6.1 Planning Permit Application: TP-2021-603, Queen Victoria Market, Food Hall, 68-81 Victoria Street, Melbourne

**Agenda Item 6.1: TP-2021-603, Queen Victoria Market Food Hall, 68-81 Victoria Street, Melbourne**

**FUTURE MELBOURNE COMMITTEE MEETING  
TUESDAY 9 NOVEMBER, 2021  
AGENDA ITEM 6.3 - MACAULAY STRUCTURE PLAN**

Figure 10: Interface Street

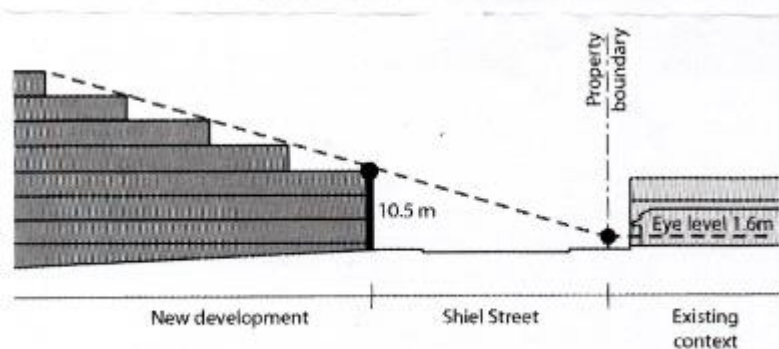
So, why has the Macaulay Structure Plan 2021 ignored DDO63 objectives and any recognition, respect or protection for Shiel Street –an established, residential, low-scale **Interface Street**?

For Shiel Street, the Macaulay Structure Plan 2021 proposes a four storey street wall, virtually no setback (only a ‘preferred’ minimum 5 metres), then a discretionary ‘preferred’ maximum height of 8 storeys. There is no justification for the change from a three storey street wall then the setbacks as shown in the Figure 10: Interface Street diagram above. [There appears no justification for the different treatment of Shiel St and nearby Melrose St, also an Interface Street, where the preferred maximum building height is 6 storeys]

Figure 10: Interface Street

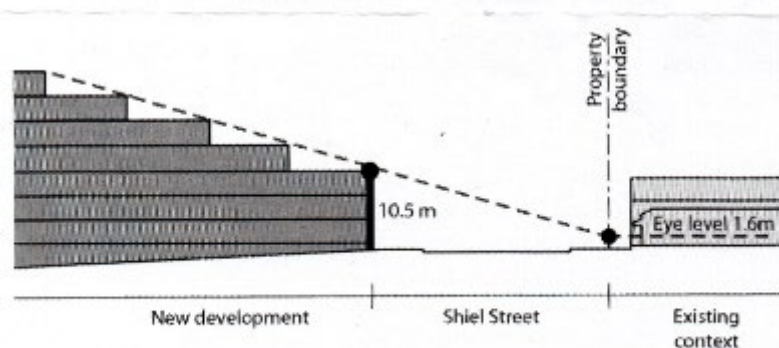
So, why has the Macaulay Structure Plan 2021 ignored DDO63 objectives and any recognition, respect or protection for Shiel Street –an established, residential, low-scale **Interface Street**?

For Shiel Street, the Macaulay Structure Plan 2021 proposes a four storey street wall, virtually no setback (only a ‘preferred’ minimum 5 metres), then a discretionary ‘preferred’ maximum height of 8 storeys. There is no justification for the change from a three storey street wall then the setbacks as shown in the Figure 10: Interface Street diagram above. [There appears no justification for the different treatment of Shiel St and nearby Melrose St, also an Interface Street, where the preferred maximum building height is 6 storeys]

Figure 5: The Stubbs Precinct area bounded by Barnett, Robertson and Stubbs Streets and Macaulay Road

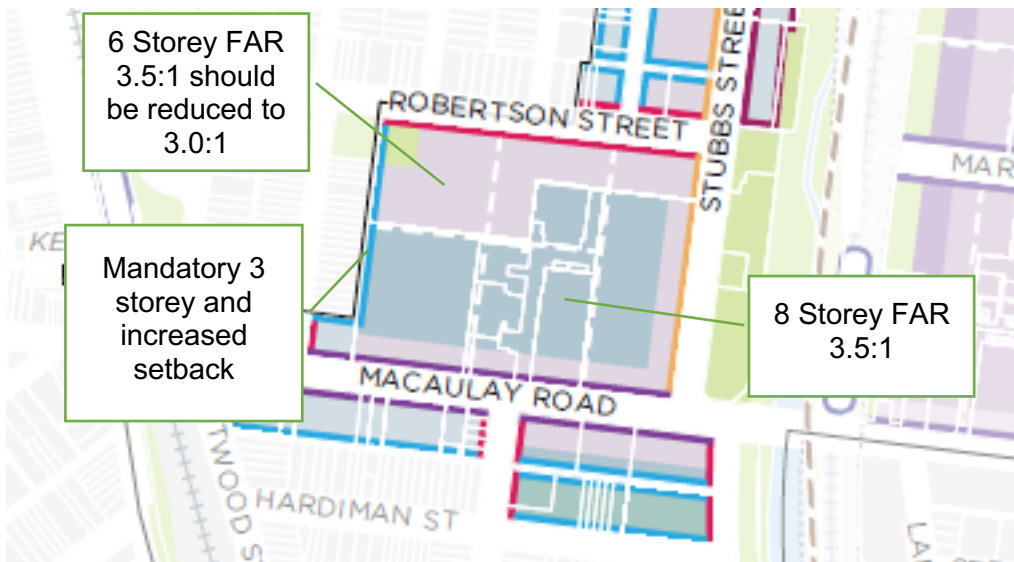
For instance, within the region of Stubbs Precinct bounded by Barnett, Robertson and Stubbs Streets and Macaulay Road, see Figure 5, the propose height maximums are 6 storeys for the lilac shade areas and 8 storeys for the grey shade area.

As developers will build to maximise the planning controls the impact of having the same FAR but different building heights will mean that the built form in the lilac region bounded by Robertson Street will be more homogenised with less open space than intended. To encourage heterogeneity the FAR should be reduced to 3.0:1, lowering the density and encouraging more open space between the dwellings.

Figure 10: Interface Street

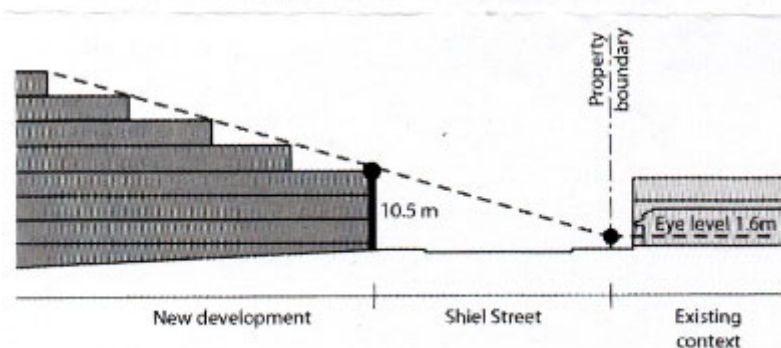
So, why has the Macaulay Structure Plan 2021 ignored DDO63 objectives and any recognition, respect or protection for Shiel Street –an established, residential, low-scale **Interface Street**?

For Shiel Street, the Macaulay Structure Plan 2021 proposes a four storey street wall, virtually no setback (only a ‘preferred’ minimum 5 metres), then a discretionary ‘preferred’ maximum height of 8 storeys. There is no justification for the change from a three storey street wall then the setbacks as shown in the Figure 10: Interface Street diagram above. [There appears no justification for the different treatment of Shiel St and nearby Melrose St, also an Interface Street, where the preferred maximum building height is 6 storeys]
